HISTORIC AND DESIGN REVIEW COMMISSION

Agenda Item No: 2

HDRC CASE NO: 2015-151
ADDRESS: 1033 DAWSON ST
LEGAL DESCRIPTION: NCB 2872 BLK N LOT 8
ZONING: R6 H
CITY COUNCIL DIST.: 2
DISTRICT: Dignowity Hill Historic District
APPLICANT: Focal Design Builders
OWNER: Focal Design Builders
TYPE OF WORK: Exterior repairs and alterations, construct rear deck, and replace windows
REQUEST:

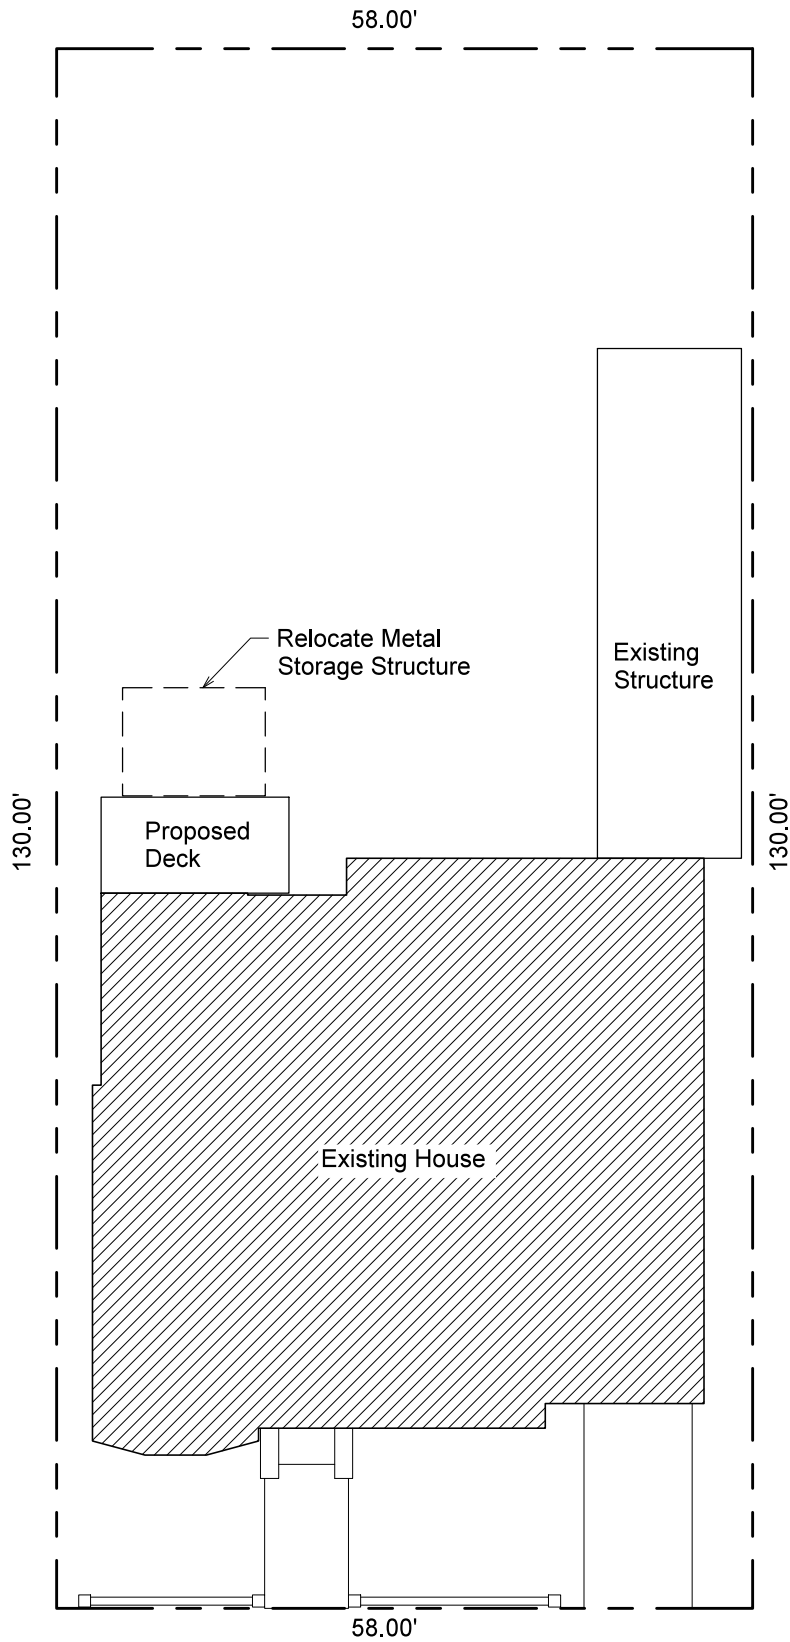
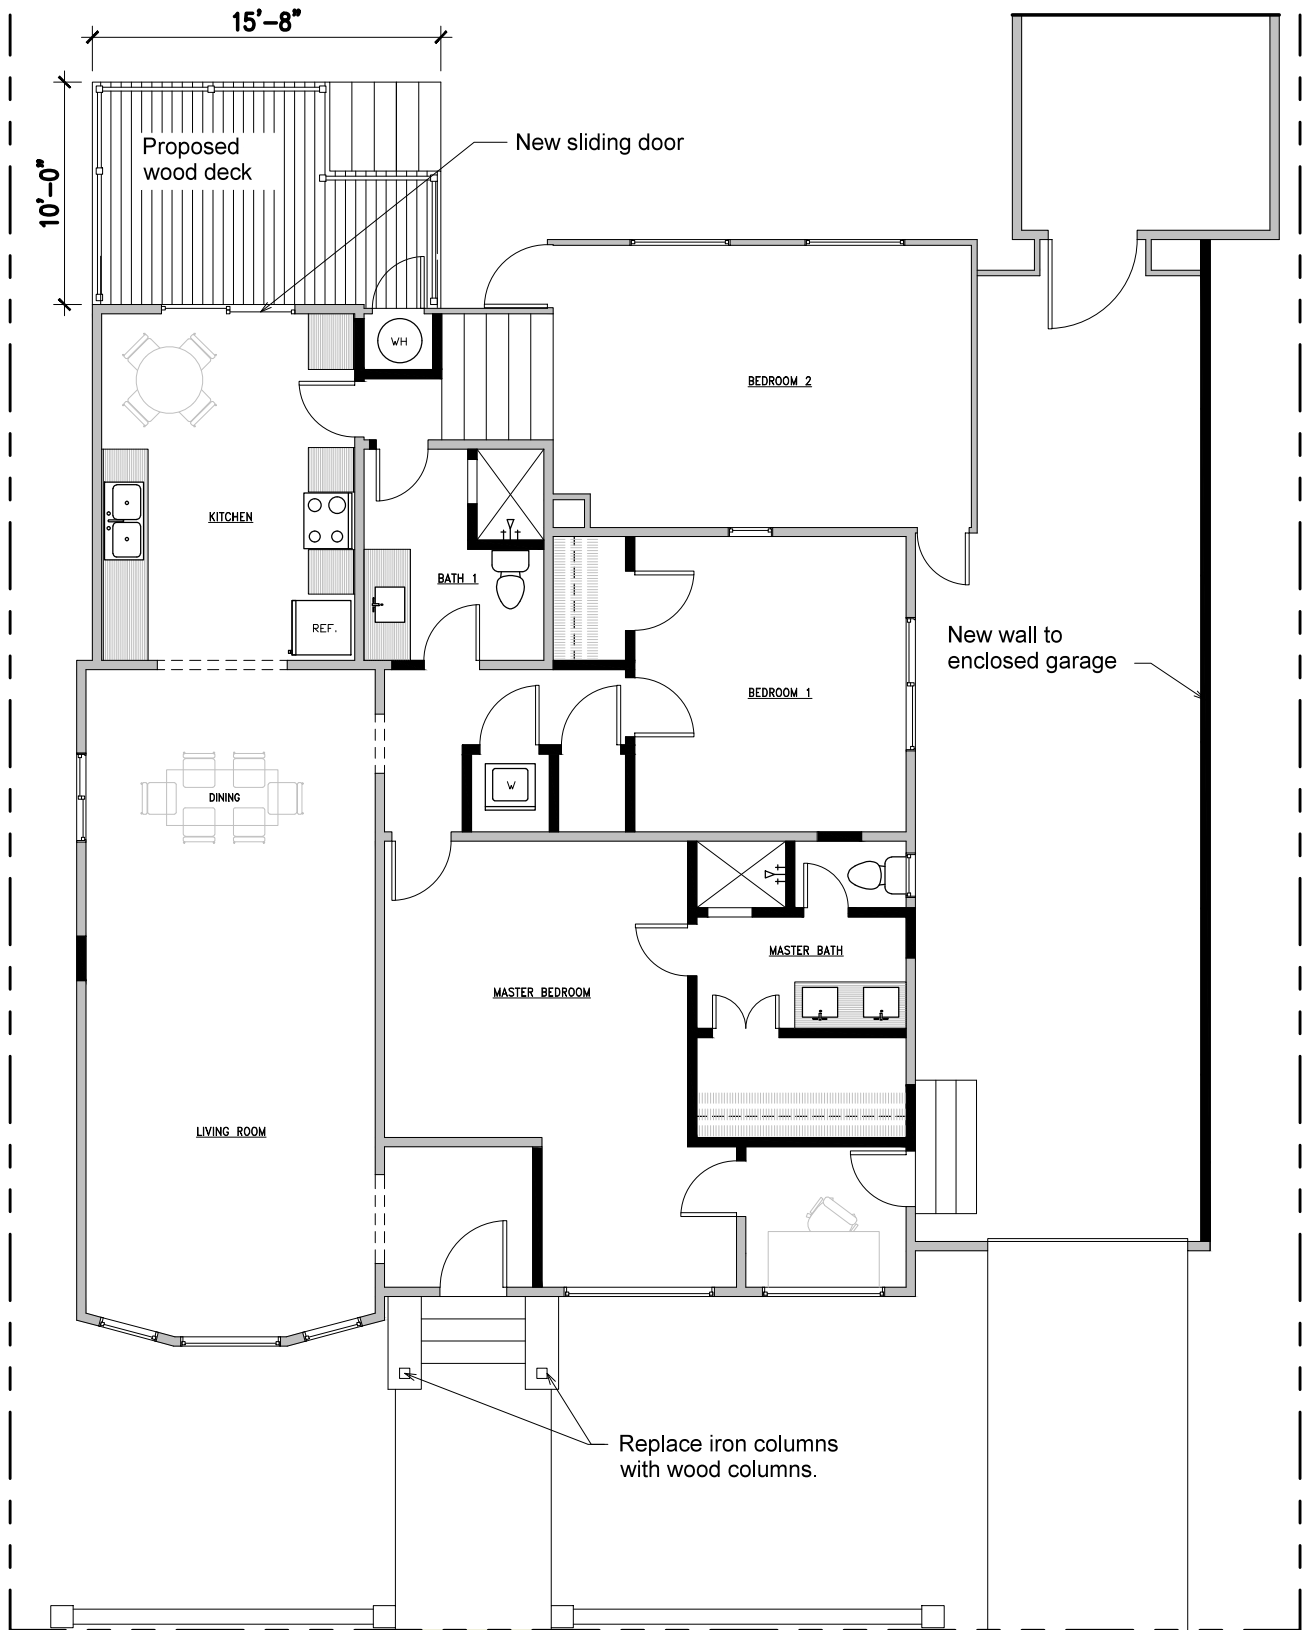
- c. According to pictures submitted by the applicant, there are at least two original wood windows on the house which should be preserved. Although replacement of the existing aluminum windows may be appropriate, the proposed vinyl windows are not consistent with the architectural style of the building. In addition, the proposed windows will be mounted flush on the wall instead of set inside the opening as typical with historic windows. A replacement window that matches historic windows in proportion, size and placement of brickmolds, blind stops, and rails would be more appropriate.

1. Staff recommends approval of item 1 based on finding c with the stipulation that if wood is uncovered under the existing siding, it is restored rather than replaced or covered with stucco.
2. Staff recommends approval of item 2 based on finding a with the following stipulations:
 - a. The applicant submits an appropriate replacement option to staff for approval.
 - b. All wood windows are retained and repaired instead
3. Staff recommends approval of item 3 based on finding d with the stipulation that the metal roof has panels 18-21" wide and ridges less than 2" high.
4. Staff recommends approval of item 4 as submitted based on finding e.
5. Staff recommends approval of item 5 as submitted in option 1 based on finding f.
